The Town of Hilton Head Island Regular Design Review Board Meeting

The Town of Hilton Head Island
DESIGN REVIEW BOARD
Minutes of the Tuesday, June 14, 2011 Meeting
1:15pm – Benjamin M. Racusin Council Chambers

**BROAD CREEK MARINA
ECO TOURISM PARK ZIP LINE CANOPY TOUR
DRB NARRATIVE
June 10, 2011**

DESIGN TEAM/ DRB COMMENT SHEET

Broad Creek Marina Zipline Canopy Tour Access/Egress Towers

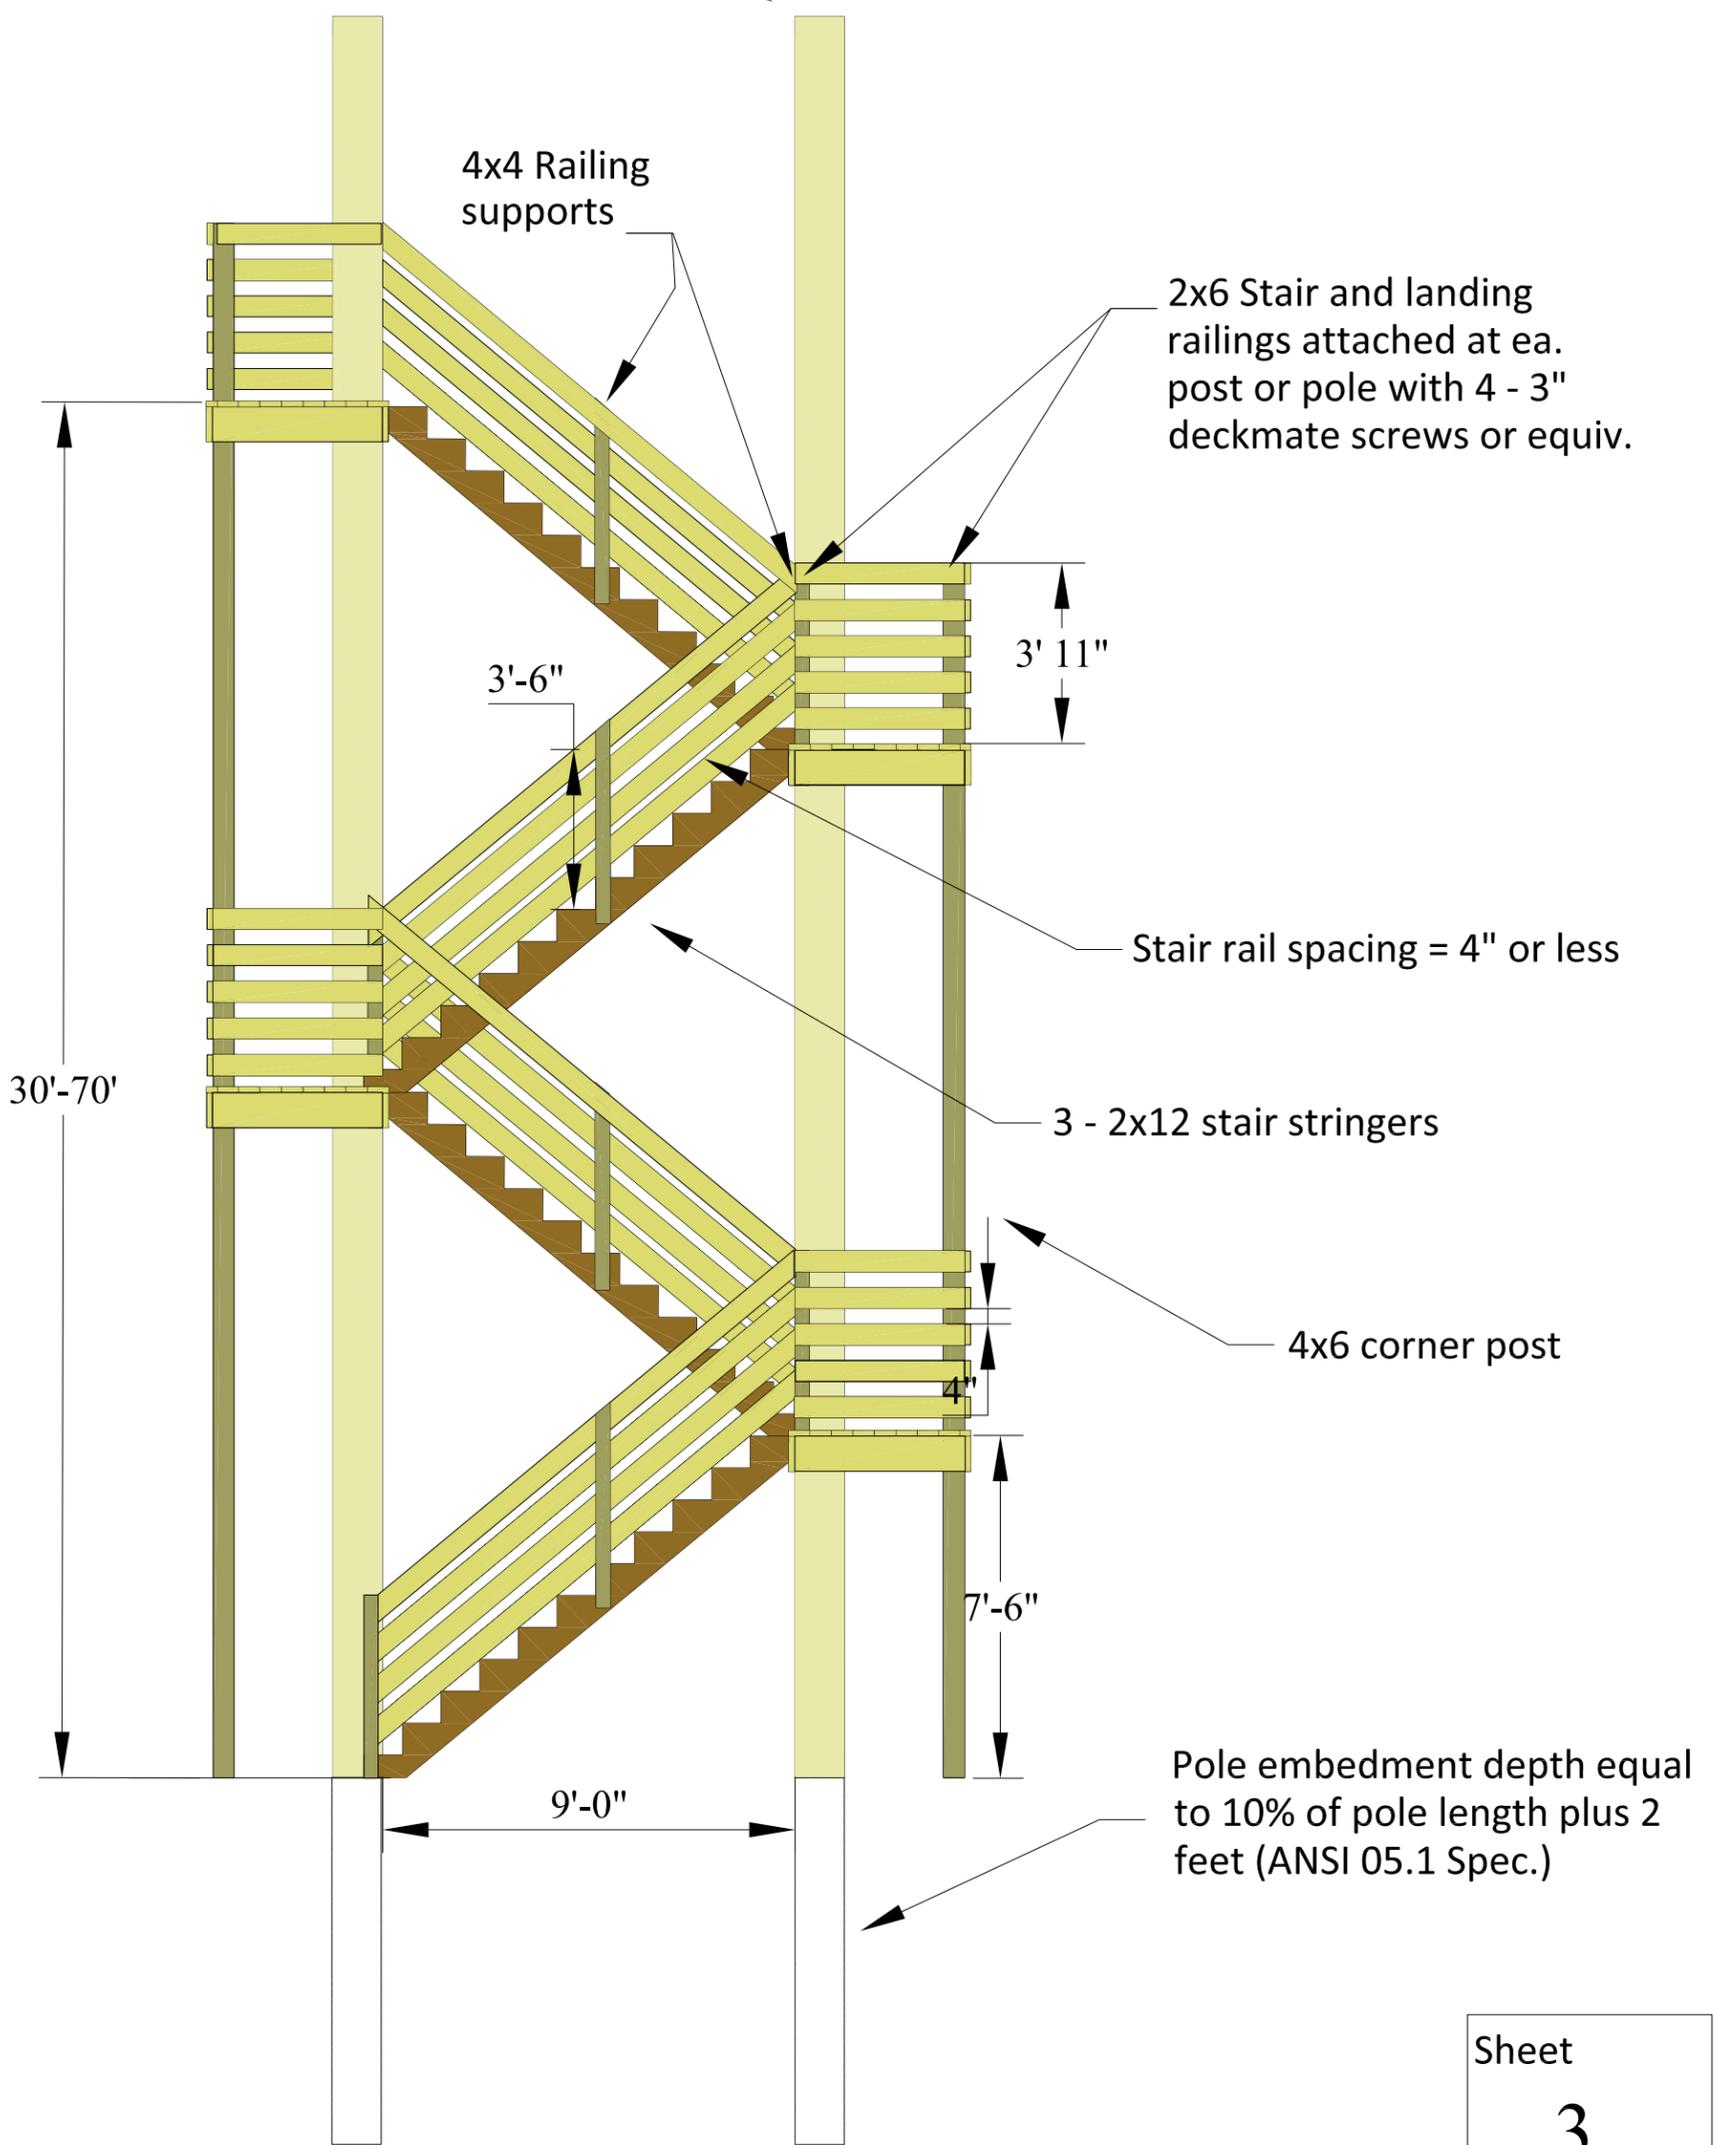
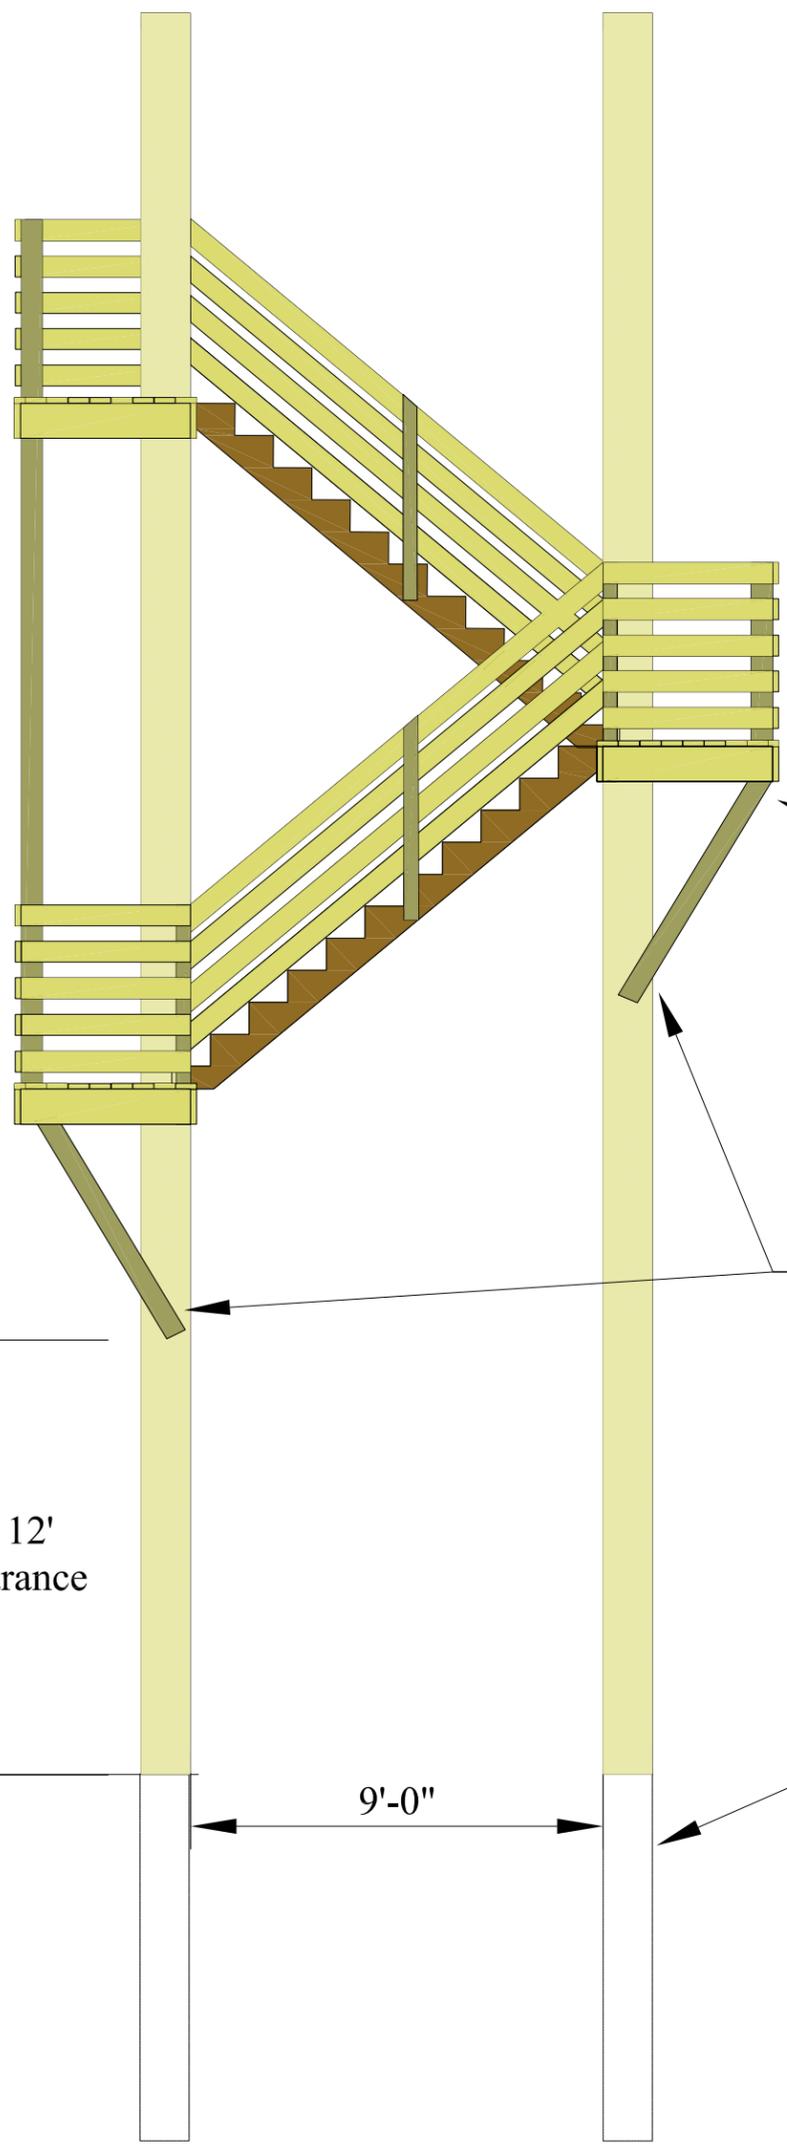
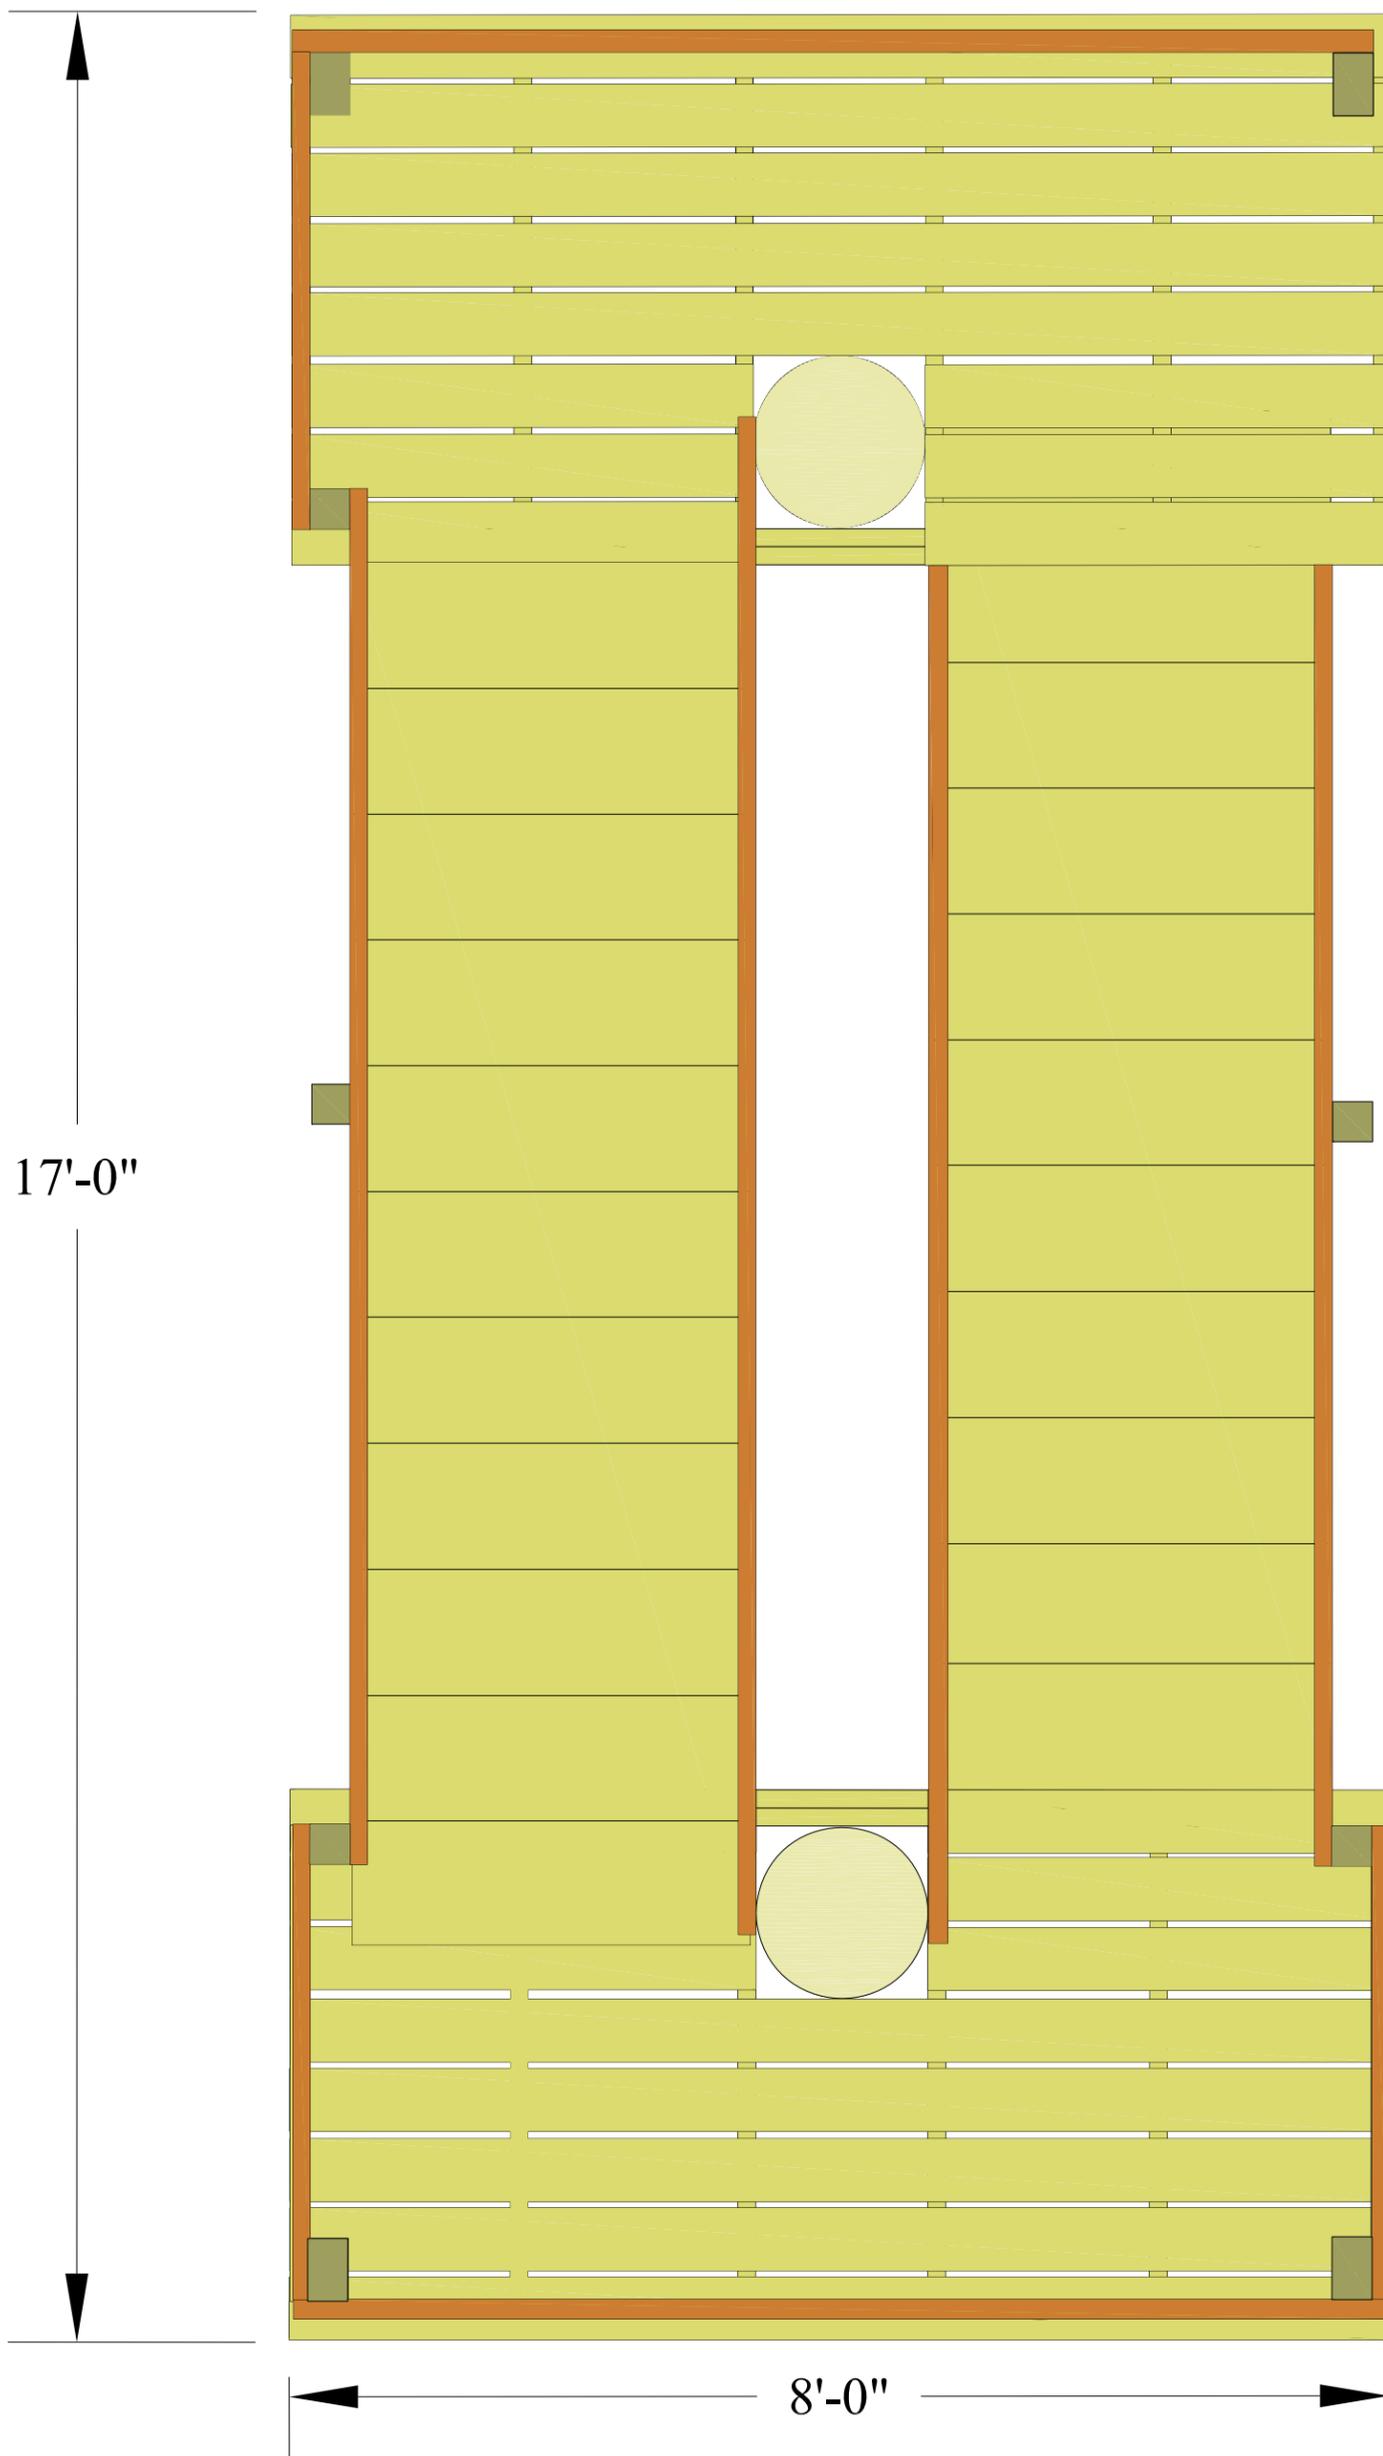
Detailing is chunky and rustic, which is probably appropriate for the unique use and qualities of the structures. 2x6 railing elements and brackets might benefit from some refinement, relative to the Design Guide, although that might not be in keeping with the design intent. This is a project with no real precedent on the Island, and it warrants some discussion amongst the Board, relative to the level of detail that is appropriate. As proposed, however, it generally meets the intent of the Guide.
